WATER RESOURCES DEPARTMENT

MEMO

Date: September 26, 2016TO: Application: 18349FROM: GW: Aurora C. Bouchier
(Reviewer's Name)SUBJECT: Scenic Waterway Interference & General/Local Surface Water
Evaluation for Deschutes Ground Water Study AreaThe source of appropriation is within or above the Deschutes
Scenic Waterway.

TO: Water Rights Section Date September 26, 2016
 FROM: Groundwater Section Aurora C Bouchier
 SUBJECT: Application G- 18349 Reviewer's Name Supersedes review of na
 Date of Review(s)

Well Location Map

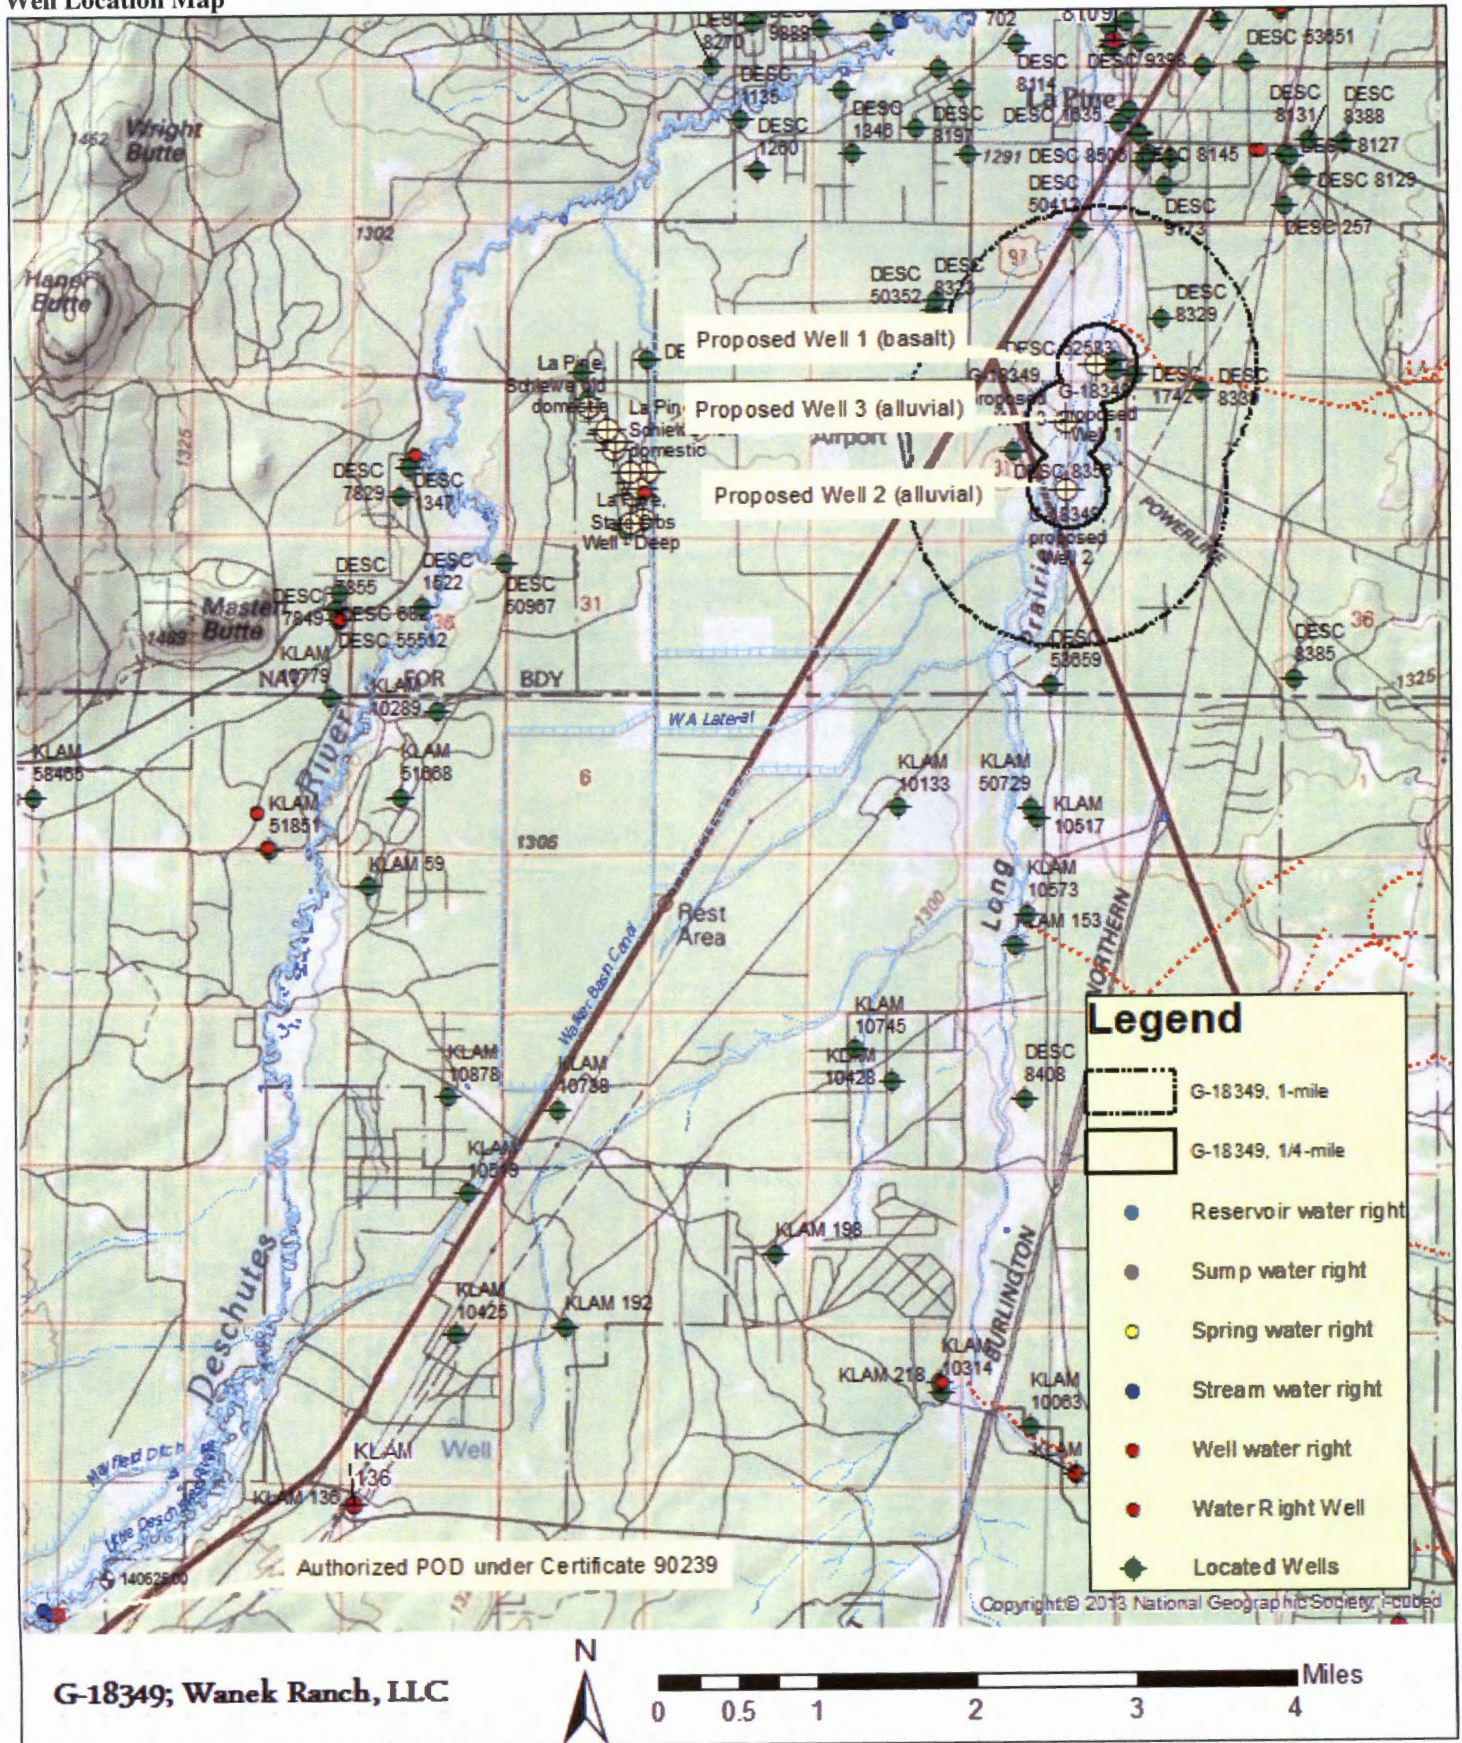
A4. **Comments:** *The proposed location description for Well 1 places the well on the west side of Long Prairie Slough and in the SW1/4 of the SE1/4 of Section 22. The map shows Well 1 on the east side of the slough and in the SE1/4 of the SE1/4 of Section 22. The estimated static water levels and well construction are provided in the application based on basalt well DESC 55049** and alluvial well DESC 57682***.
